Access Compliance Report Public Rights-of-Way (Curb Ramps)

Main Street: N/A Cross Street: MEDANO_ST Location: NE

ADA ID: RPRK211201141326 Ramp Type: Type 7 - Directional 2 Initial Pass/Fail: Fail Overall Compliance: No Severity Score: 2

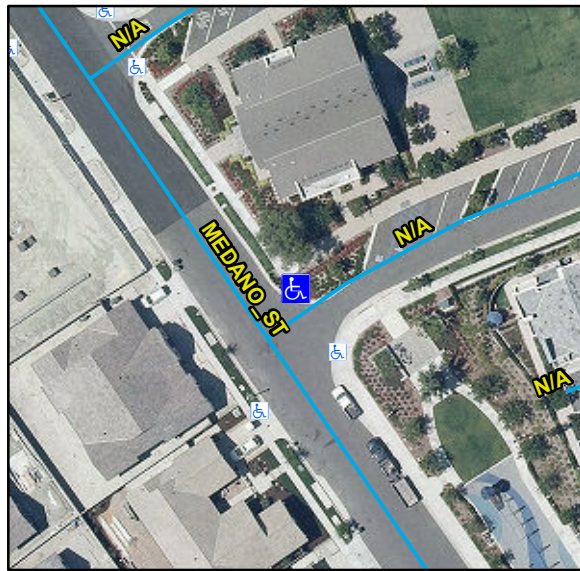
Compliance	Description	Data	Compliance	Description	Data
N/A	Ramp Length (in)	135	N/A	Flare Type LT	
Yes	Ramp Width (in)	60			N/A
Yes	Ramp Run Slope (%)	4.4	N/A	Flare Slope LT (%)	N/A
No	Ramp Cross Slope (%)	2.4	N/A	Flare Traversable LT	N/A
N/A	Grade Break	N/A	N/A	Flare Type RT	
N/A	Grade Break Slope (%)	N/A			N/A
N/A	Grade Break Cross Slope (%)	N/A	N/A	Flare Slope RT (%)	N/A
	Addl Para Ramp Left?	No	N/A	Flare Traversable RT	N/A
	Addl Para Ramp Right?	No	N/A	DWS Provided	N/A
N/A	Landing Present	N/A	N/A	DWS Contrast	N/A
N/A	Landing Length (in)	N/A	N/A	DWS Length (in)	N/A
N/A	Landing Width (in)	N/A	N/A	DWS Full Width	N/A
N/A	Landing Run Slope (%)	N/A		DWS Offset Type	N/A
N/A	Landing Cross Slope (%)	N/A	N/A	DWS Left Offset (in)	N/A
N/A	Landing Movement Obstructed?	N/A	N/A	DWS Right Offset (in)	N/A
	Landing Movement Type	N/A			
N/A	Landing Shared	N/A			
N/A	Marked Crosswalk 1	No	N/A	Clear Space	N/A
	Crossing 1 Direction	S	N/A	Clear Space To Crosswalk (in)	N/A

Remove & Replace Entire Ramp.
